TRANS/WP.29/GRSP/2005/9  
30 March 2005

Working Party on Passive Safety (GRSP)  
(Thirty-seventh session, 23-27 May 2005,  
agenda item B.1.8.)

**PROPOSAL FOR DRAFT AMENDMENTS TO REGULATION No. 11**

(Door latches and door retention components)

Figure 3-1 – Door Latch - Tensile Testing Fixture for Load Test One

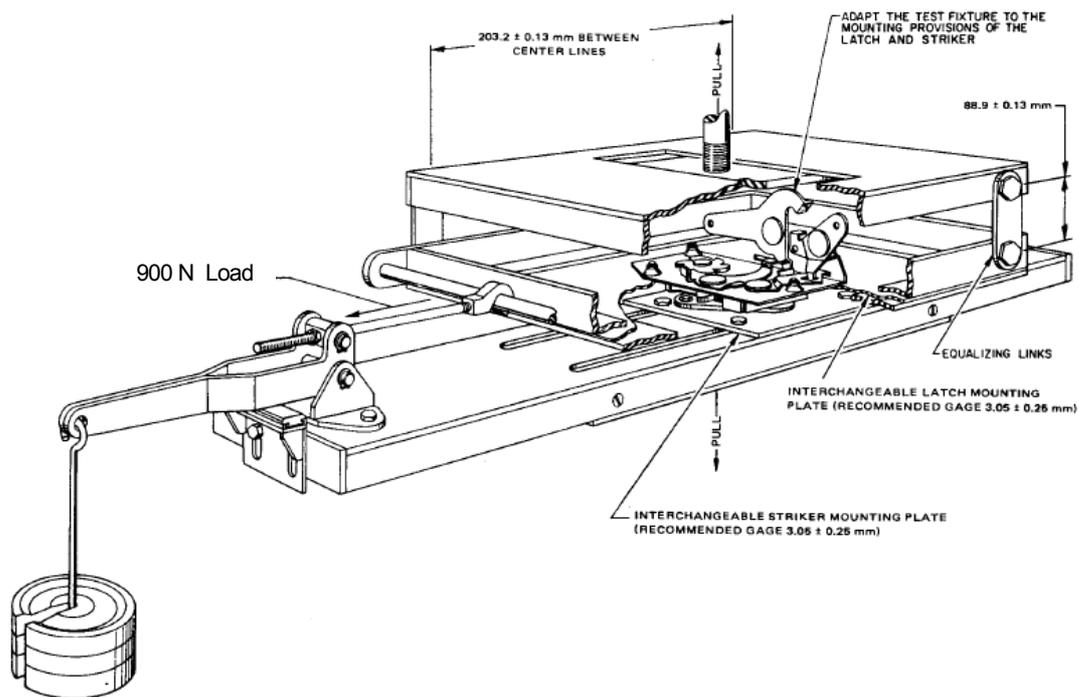
2.1.1. Equipment: Tensile testing fixture (see Figure 3-1).

Figure 3-2 – Door Latch – Tensile Testing Fixture for Load Test Two

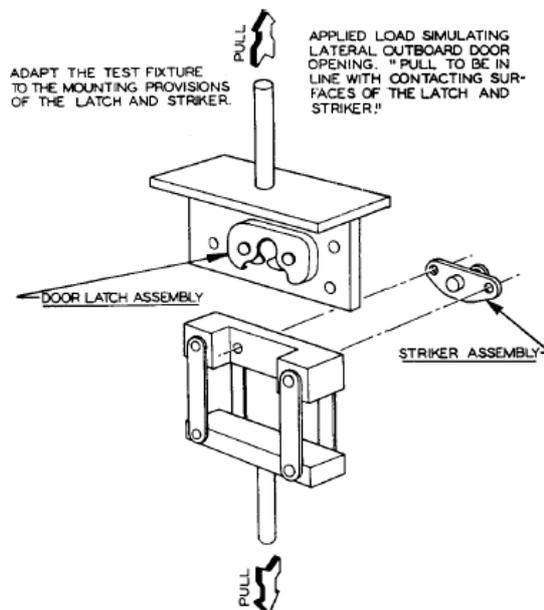
2.2.1. Equipment: Tensile testing fixture (see Figure 3-2).

Figure 3-3 - Door Latch – Tensile Testing Fixture for Load Test Three (Back Doors Only)

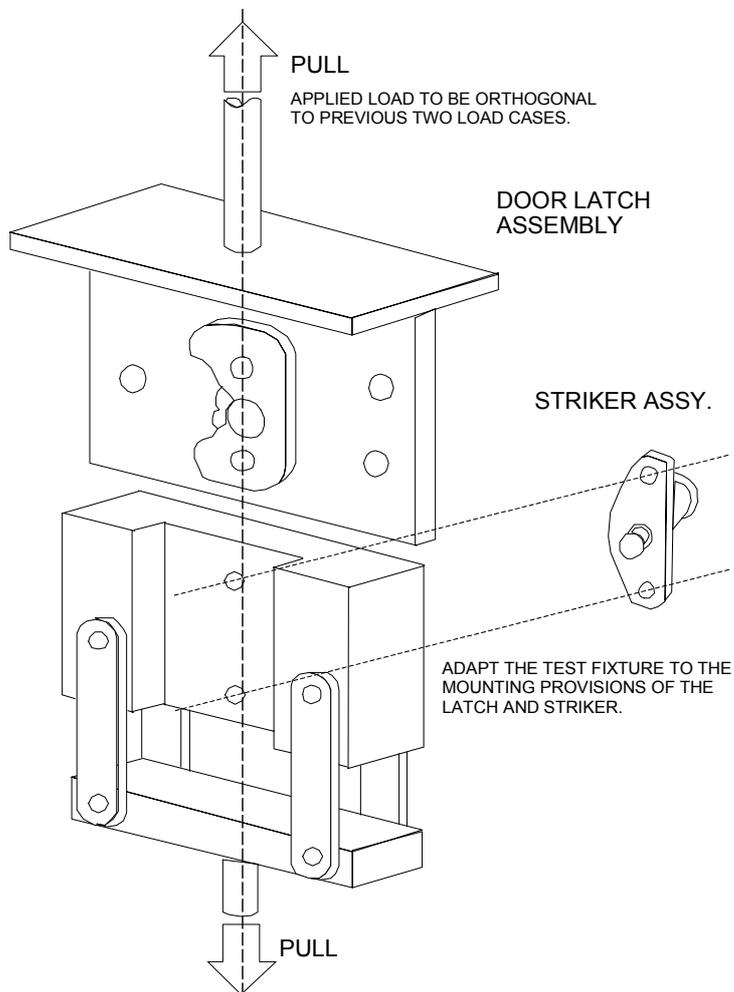
- 2.3. Load Test Three (Back Doors Only)
  - 2.3.1. Equipment: Tensile testing fixture (see Figure 3-3).
  - 2.3.2. Procedure
    - 2.3.2.1. Adapt the test fixture to the mounting provisions of the latch and striker. Mount the latch and striker in the fully latched position to the test fixture.

Figure 3-4 – Door Static Load Test Directions"

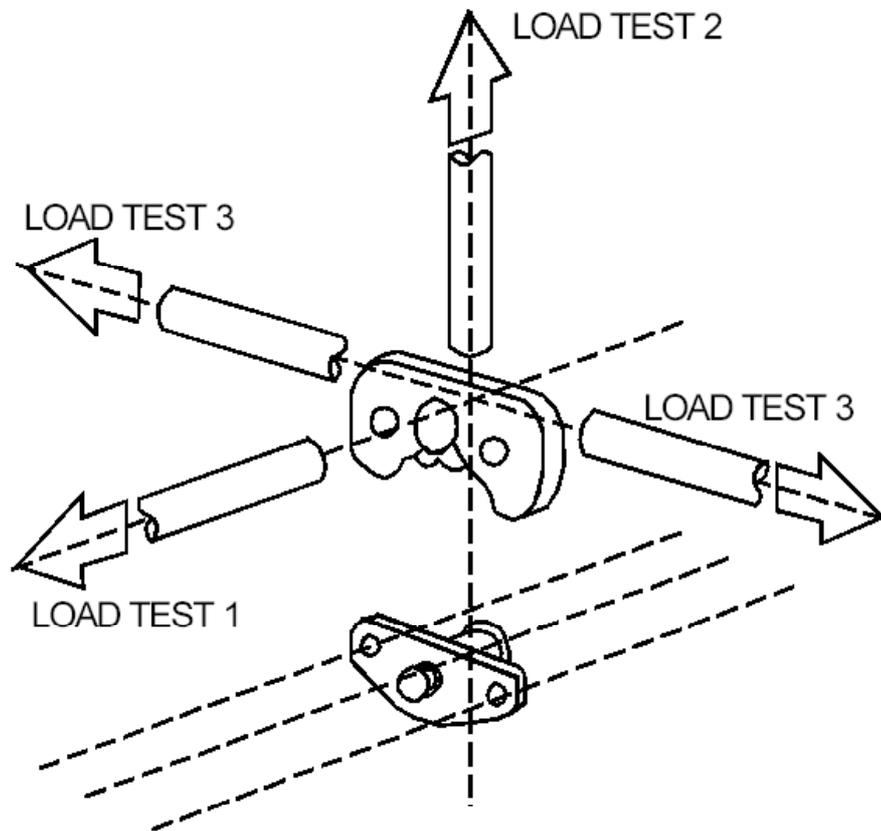
2.1.2.1.3. Apply the test load, in the direction specified in paragraph 6.1.1. of this regulation and Figure 3-4, at a rate not to exceed 5 mm/min until the required load has been achieved. Record the maximum load achieved.

**Figure 4-1 – Inertial Loading - Sample Calculation**

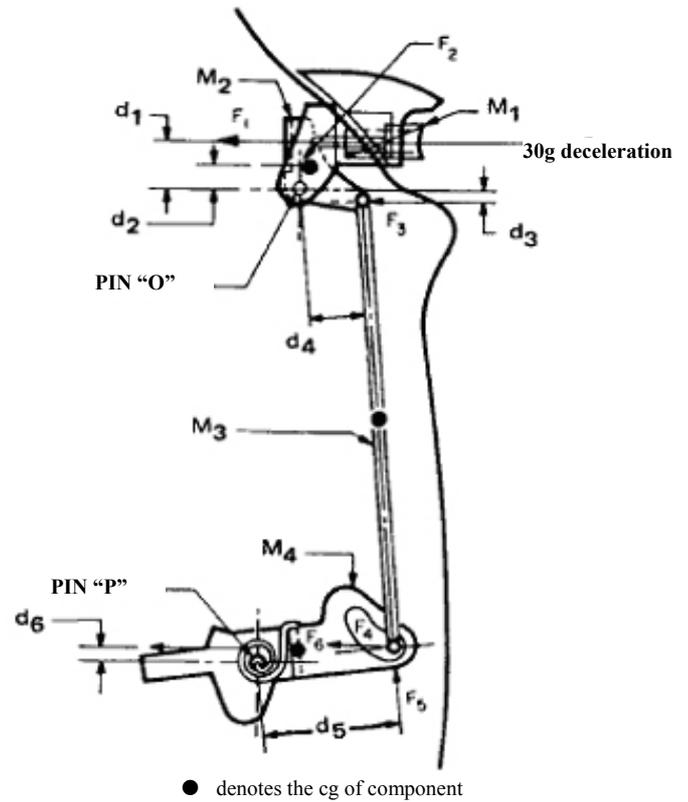
Given:  
 Door latch system subjected to a 30g deceleration  
 Average Push-Button Spring Output Force = 0.459kgf  
 Pawl Spring Output Torque = 0.0459kgf m  
 $a = 30g \text{ (m/s}^2\text{)}$   
 $F = ma = m \cdot 30g = m \cdot 294.2$

$$F_1 = M_1 \times a - \text{Average load on knob spring} = (0.0163\text{kg} \times 30g) - 0.459\text{kgf} = 0.03\text{kgf}$$

$$\begin{aligned} \Sigma M_o &= F_1 \times d_1 + F_2 \times d_2 - F_3 \times d_3 \\ &= 0.03 \times 31.5 + 0.681 \times 10.67 - 0.183 \times 4.83 \\ &= 7.33\text{kgf mm} \end{aligned}$$

$$\begin{aligned} \Sigma M_o &= \text{Pawl spring output torque} - (F_5 \times d_5 + F_6 \times d_6)/1000 \\ &= 0.0459 - (0.2328 \times 37.59 + 1.266 \times 1.9)/1000 \\ &= 0.0347\text{kgf m} \end{aligned}$$

Figure 4-2 – Acceleration Pulse

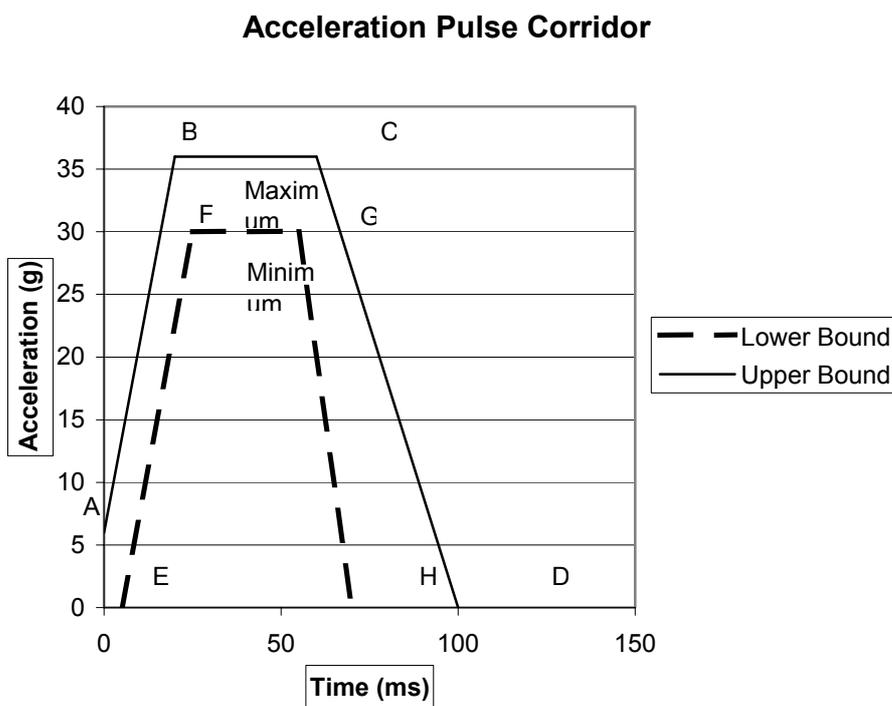
2.4.1. A minimum acceleration level of 30g shall be maintained over a period of at least 30 ms, while keeping the acceleration within the pulse corridor as defined in Table 4-1 and graphically shown in Figure 4-2.

Figure 4-3 - Vehicle Coordinate Reference System for Inertial Testing

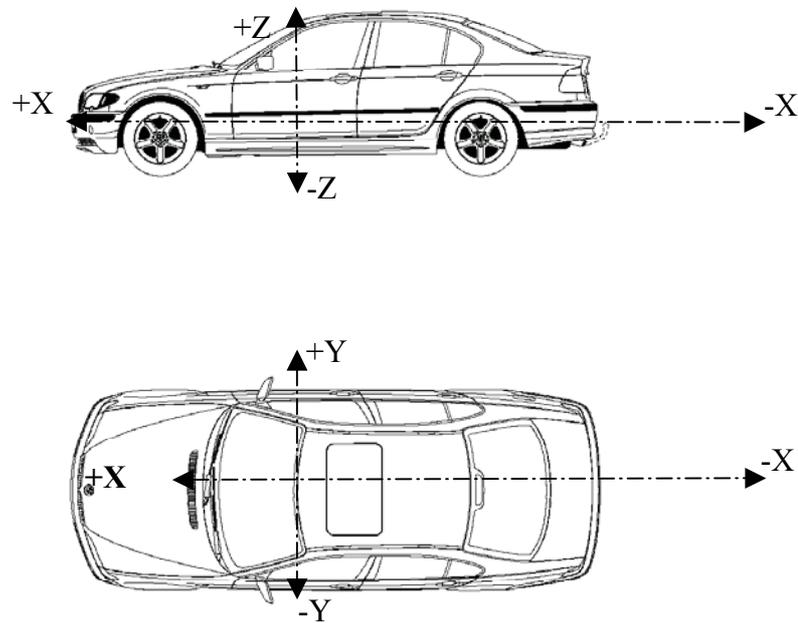
- 2.2.3. Test Directions (see Figure 4-3)
  - 2.2.3.1. Longitudinal Setup 1. Orient the vehicle or body in white so that its longitudinal axis is aligned with the axis of the acceleration device, simulating a frontal impact.

Figure 5-1 – Static test fixtures

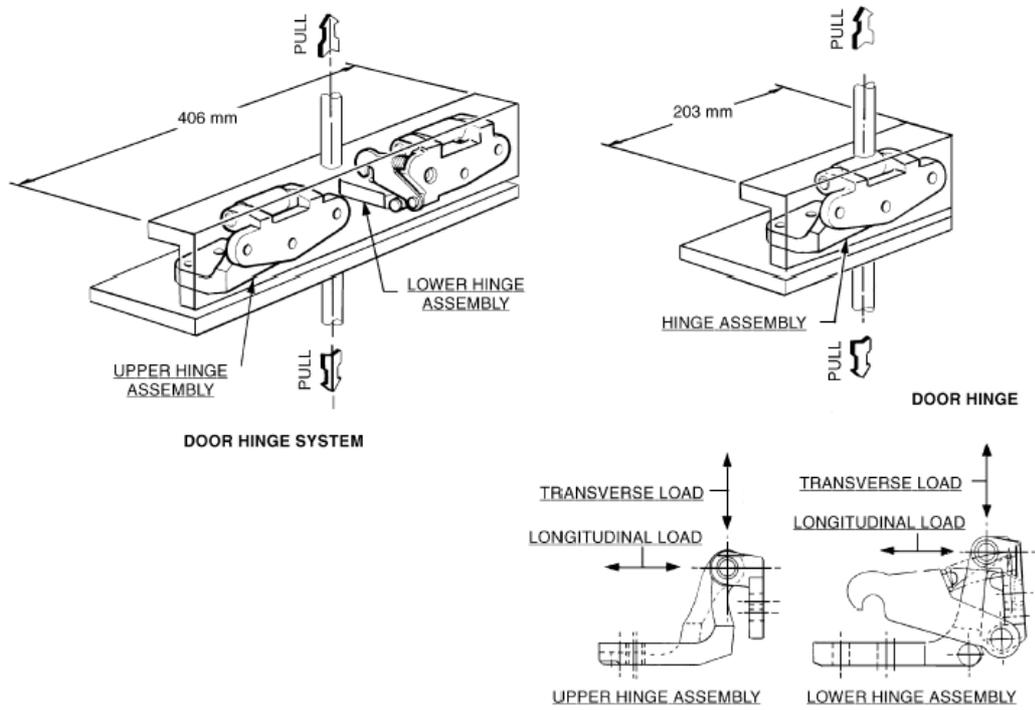
2.1.1.1.2. A typical static test fixture is illustrated in Figure 5-1.

Figure 5-2 – Static load test directions for back doors

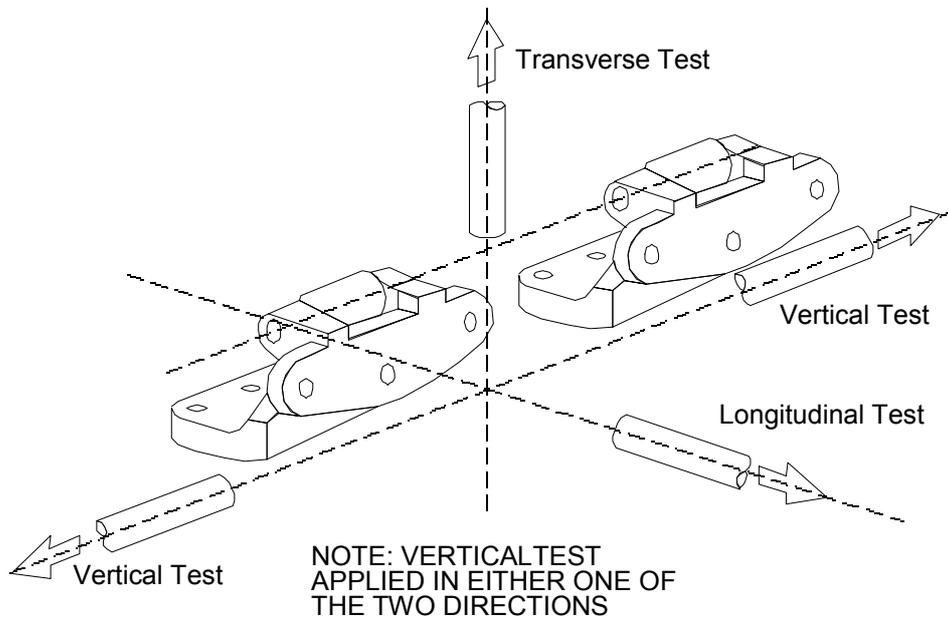
2.1.1.2.1. Attach the hinge system to the mounting provision of the test fixture. Hinge attitude must simulate vehicle position (door fully closed) relative to the hinge centreline. For test purposes, the distance between the extreme ends of one hinge in the system to the extreme end of another hinge in the system is to be set at  $406 \pm 4$  mm. The load is to be applied equidistant between the linear centre of the engaged portions of the hinge pin and through the centreline of the hinge pin in the longitudinal vehicle direction. (see Figure 5-2)

**Figure 6-1** – Sliding Side Door Full Vehicle Test Procedure  
(Note: Sliding door is shown separated from the vehicle)"

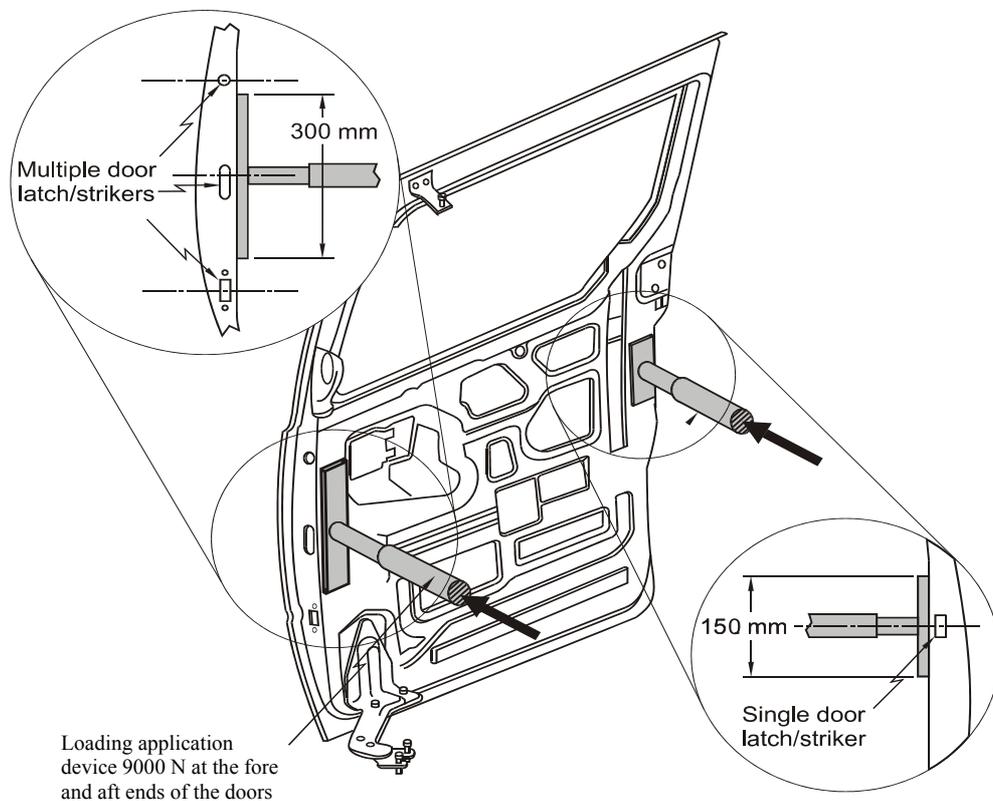
2.2. The test is conducted using two force application devices capable of applying the outward transverse forces specified in paragraph 6.2.4. of this regulation. The test setup is shown in Figure 6-1. The force application system shall include the following:
